(+49) 991 9106 83 Service
(+49) 991 9106 24 EngineeringE-Mail: service@zierer.comInternet: www.zierer.com**Service Bulletin**

Zierer Bulletin #	Revision:	Page	System	Description:	Date:	Issued:
SB-WS-1001_rev1	1	1 of 4	Wave Swinger	Service Bulletin	17.01.2013	wmt
Original Ride Manufacturer			Release Date	Affected Production Dates:	Ride Name:	
ZIERER – Karussell und Spezialmaschinenbau			18.12.2012	2011 and earlier	Wave Swinger

With reference to EN 13814 and in cooperation with the German Authority TUEV, we would like to inform you about some components recently added to the Zierer Wave Swinger; in order to improve the rides safety.

3. Modifications:**3.1. Monitoring Devices at Lifting Cables****Rope Monitor Zierer Article No.: VK080063**

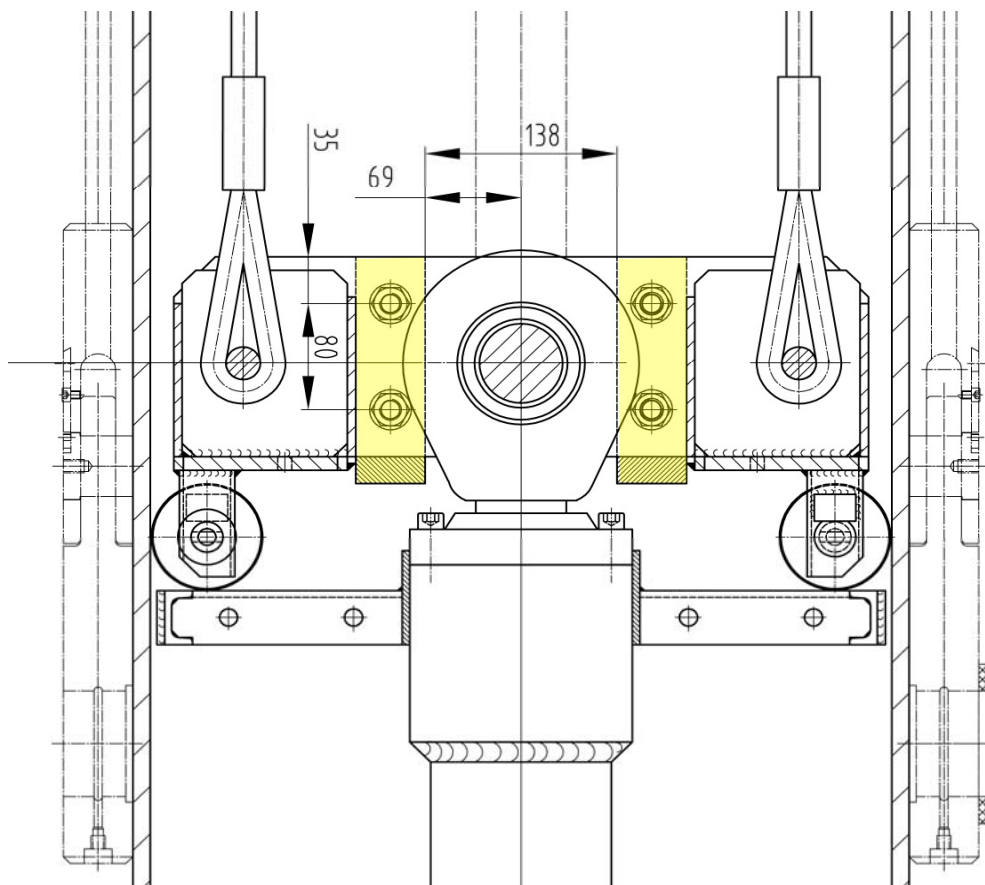
2 sets of sensors monitoring the smooth movement of the lifting cables. The sensors are mounted on a bracket which is bolted to the bottom of the sheave compartment right next to the entry hole of the lifting cables. Their signals need to be integrated into the ride control system subsequently.

If for any reason a cable moves out of sensing range the control system will initiate a “Fast Stop” function .

This modification requires at least three additional slip rings at the slip ring assembly in the lower mast portion. If spare slip rings are available on your unit we recommend the addition of the rope monitor to your Wave Swinger on the next occasion (e.g. winter rehab).

It is no need to take any action if the slip ring assembly on your unit does not have this requirement. Just make sure a thorough daily visual inspection on both sets of lifting cables prior to public operation as well as the required monthly checks over the entire cable length gets carried out.

In case the slip ring assembly on your unit is worn and needs to be replaced soon we would recommend purchasing a slip ring assembly with more slip rings, so that the rope monitor can be added.

3.2 Lifting Cylinder Retaining Elements [Cylinder Rod] Zierer Article No.: HZ020078

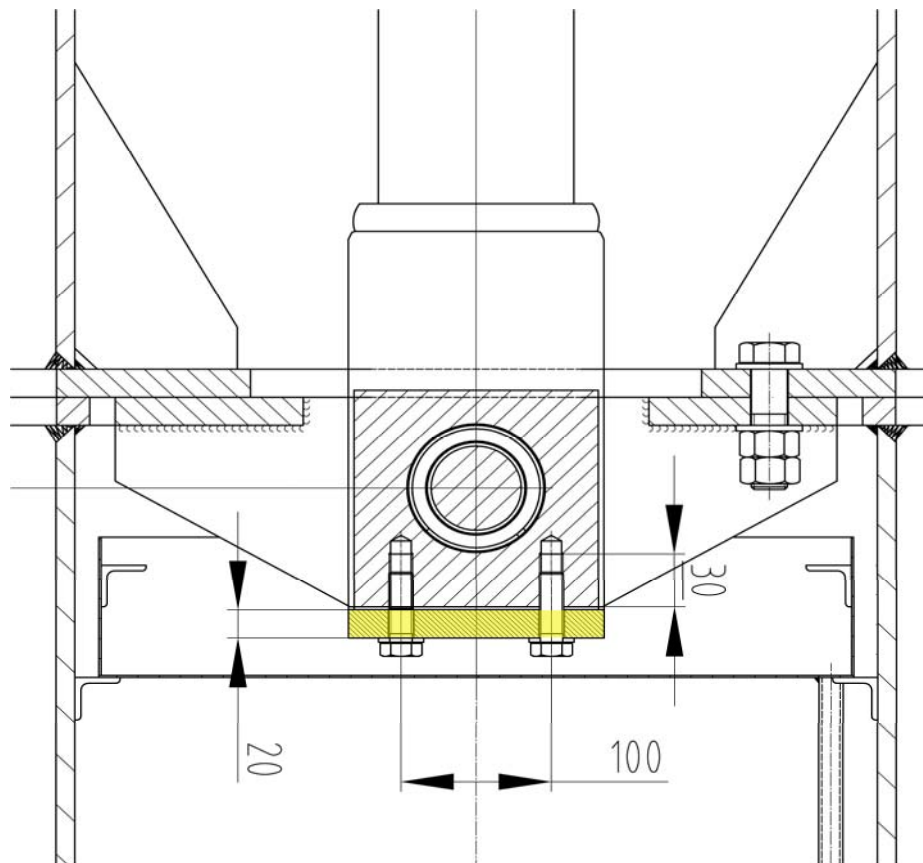
In case of a break of the suspension pin 2 pieces of fork shaped retaining elements preventing the rod end from slipping through the guiding cross. The retaining elements are mounted axially at a distance of 138 mm with 4 bolts to each side of the guiding cross.

We recommend proceeding with this modification on the next occasion (e.g. next winter rehab), provided that the suspension pin has been inspected and documented as requested in the NDT requirement

3.3 Lifting Cylinder Retaining Element [Cylinder Barrel] Zierer Article No.: HZ020079

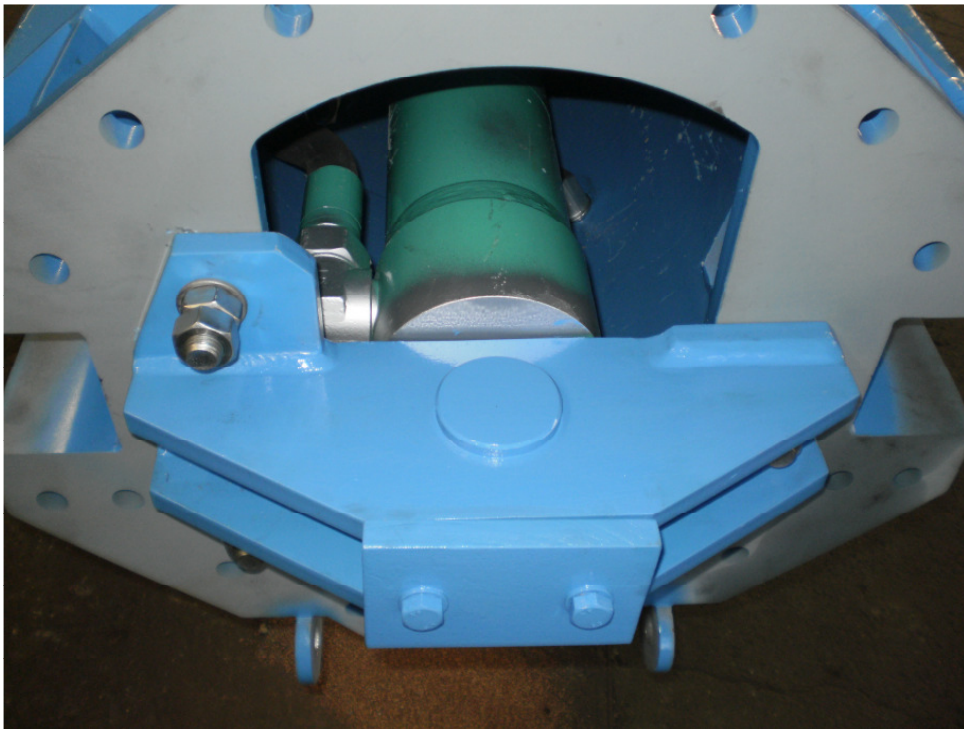
In case of a break of the suspension pin a striker plate prevents the cylinder from slipping out of the clamping device. The striker plate is bolted concentric to the cylinder eye by means of 2 bolts.

This modification requires a rectangular shape of the eye on the cylinder barrel. This can be found only on cylinders built in 2010 or later.

If you have purchased a new cylinder during or after 2010 we recommend proceeding with this modification on the next occasion (e.g. next winter rehab) provided that the suspension pin has been inspected and documented as requested in the NDT requirement.

If the lifting cylinder on your unit does not have this requirement please proceed as usual. By purchasing of a new lifting cylinder the striker plate will be included in the shipment.
